Work Order ID 164212

Item ID: D206-642-341BL Accept ***N900040100*** Setup Start ***NS1***
Revision ID: Stop ***NS2***
Item Name: Replacement Skidtube (Fits LH or RH)
Start Date: 8/4/2017 Start Qty: 1.00 ***1*** Cust Item ID:
Required Date: 9/25/2017 Req'd Qty: 1.00 ***1*** Customer:
Reference:

DRAWING NO. D2650	TITLE 206/407 SKIDTUBE ASSEMBLIES	REV. F	DART AEROSPACE LTD ENGINEERING ORDER		D.E.O. NO. D2650-F-1	SHEET NO. SHEET 1 OF 1	SCALE NTS
DRAWN <i>[Signature]</i>	CHECKED A.P.	MFG. APPR. <i>[Signature]</i>	APPROVED <i>[Signature]</i>		DE APPR. <i>[Signature]</i>		
DATE 12.10.12	DATE 12.10.22	DATE 12.10.22	DATE 12.10.22		DATE 12.10.22

AMENDMENT TO DETAIL B
NOT TO SCALE

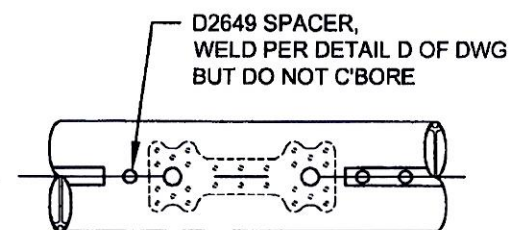
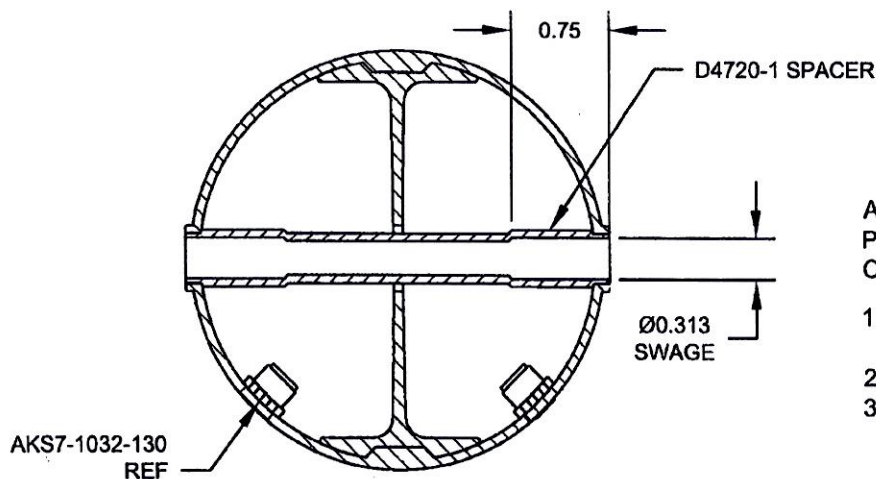
PURPOSE:

CHANGE C'BORED WELDED CROSSBOLT SPACERS TO SWAGED SPACERS

ADD DETAIL G BELOW, WHICH IS THE SAME SECTION VIEW AS DETAIL D OF DWG.

C'BORED HOLES ARE NOW SWAGED PER DETAIL G BELOW. FOR THE Ø0.375 HOLE THAT IS NOT C'BORED, WELD PER DETAIL D OF DWG (SEE AMENDED DETAIL B FOR REFERENCE).

DETAIL G

FOR Ø0.375 HOLES ONLY
FOR HOLES THAT ARE CURRENTLY C'BORED ONLY
NOT TO SCALE

AFTER DRILLING AND BENDING ASSEMBLY
PERFORM THE FOLLOWING FOR Ø0.375 HOLES THAT ARE
CURRENTLY C'BORED:

1. INSERT D4720-1 SPACER, 16 PL (-1) OR 17 PL (-3)
OR 19 PL (-5) OR 23 PL (-7)
2. SWAGE TO Ø0.313 X 0.75 DP PER QSI 002
3. TRIM / GRIND FLUSH PER QSI 002
